## ***Interactive comment on “Homogenizing and Estimating the Uncertainty in NOAA’s Long Term Vertical Ozone Profile Records Measured with the Electrochemical Concentration Cell Ozonesonde” by Chance W. Sterling et al.***

**Chance W. Sterling et al.**

Anonymous Referee #3 The authors would like to thank the referees for the constructive criticism of our manuscript. We have outlined our responses to the reviewers’ comments as well as the subsequent changes to the manuscript in the following response. Received and published: 1 January 2018

**Fig. 1.** Figure 1: The eight long-term NOAA ozonesonde stations with Latitude, Longitude, # of Profiles, and launch period.

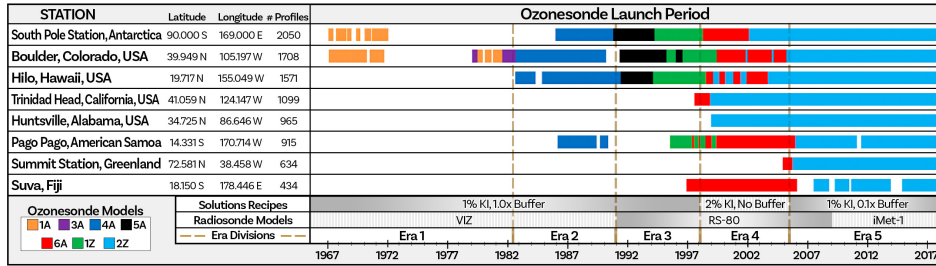
or lower characters throughout the text. Authors' Response: All instances where the name of a particular solution is being discussed have been changed to upper case letters such as 1% KI, 1.0 x Buffer Solution. When discussing buffering agents or the secondary buffer reaction, buffer was changed to lower case characters. 8. P10L10+: Get the subscript depths right. Authors' Response: Corrected in manuscript. 9. P12,13 Equations 8-13: Add unit "K". Authors' Response: The sentence on what is now Page 12 Line 19 has been updated to read, "All temperatures used in calculating ozone are in Kelvin. The pump temperature ( T\_P) is calculated by adding the differences between configurations and inside of the pump block (  $\Delta T_{(P,CIB)}$ ), and the difference between the inside of the pump block and the internal piston temperature (  $\Delta T_{(P,CIP)}$ ) to the raw pump temperature measured ( T\_(P,Meas)) with Eqn. 7:" 10. P12L21, P17L23: "degree" is not part of the unit Kelvin. Please delete. Authors' Response: Corrected in manuscript. 11. P13L1: Exchange "truest" by "best estimate of the". Authors' Response: Corrected in manuscript. 12. P16L14,17: Please use "i ĘZA A" instead of "microamps". Authors' Response: All instances of "microamps" has been changed to  $\mu A$  throughout manuscript. 13. P16L20: Please use "cm\*\*3" instead of "cc". Authors' Response: "cc" changed to cm<sup>3</sup> throughout manuscript. 14. P16L22: Check place of equation number. Authors' Response: Corrected in manuscript. 15. P17L26,27,28: Add "estimated" before temperature, e.g. "estimated 1.0 K". Authors' Response: Corrected in manuscript. 16: P17L28: Add a space between "0.5" and "K". Authors' Response: Corrected in manuscript. 17: P20L8: Delete on "and". Authors' Response: Corrected in manuscript. 18: P20L9: Add ". . . average DIFFERENCES of the . . ." Authors' Response: Corrected in manuscript. 19. P20L23 & Figures S5-S8: I assume the captions for S5-S8 mentioning Dobson instead of SBUV are wrong. Authors' Response: Yes, the captions should read SBUV instead of Dobson, except for Figure S6 as the South Pole does not have SBUV data. All captions except for Figure S5 are corrected in manuscript. 20. P21L4: "Figures 11 and S7" Authors' Response: Corrected in manuscript. 21. P21L7: "(Figure 13)" instead of "(Figures 8 & 9)" Authors' Response: Corrected in manuscript. 22. Figure 1: What is the meaning of a longitude

of 169 (East of West?) at a latitude of -90. Please add East and North units. Authors' Response: Figure 1 has been updated. The latitude and longitude now include East and North units. 23. F1: Good place to mark the different eras graphically. Authors' Response: Figure 1 has been updated to show the eras. 24. F2: Explain large bars at the end of histograms (A) and (B). Authors' Response: The following sentence has been added at what is now Page 9 Line 12 to explain the large bars at the end of the histograms (A) and (B). "In Figure 2 Panels A and B, the large number of backgrounds greater than the scale of the histograms are attributed to erroneous measurements attributed to the degraded ozone destruct filters." 25. F3: Use lower case characters. Authors' Response: Figure 3 has been updated and now reads "Boulder with dry air", "Fiji with dry air", and "Trinidad Head with dry air". 26. Table 3: Add units for second column. Authors' Response: Table has been updated and the second column now includes the units ( $\mu A$ ). A new table was added, so Table 3 is now Table 4. 27. F9-12: It would be nice to have the eras mark as in later figures.' Authors' Response: Figures 9-12 have been updated to include the era marks. 28. F13-15: The relation layer to panel character is somewhat hidden. Please repeat in the caption. Authors' Response: To make the relationship between the panels, layers, and processing more clear, the captions in Figures 13-15 have been changed and now reads "Percent difference in column ozone between the merged SBUV ozone data and the ozonesonde data at Boulder, CO. Panels E and F show Layers 1-8 (Surface - 25.45 hPa), Panels C and D show Layer 9 (25.45 - 16.06 hPa), and Panels A and B show Layer 10 (10.13 - 16.06 hPa). Panels A, C, and E show before and Panels B, D and F show after applying the ozone sensor efficiency." 29. F13-15, FS1-8: Explain colour code. Authors' Response: The different colors in the plot represent different ozonesonde types. This is shown in the legend and is consistent with all of the comparison plots.
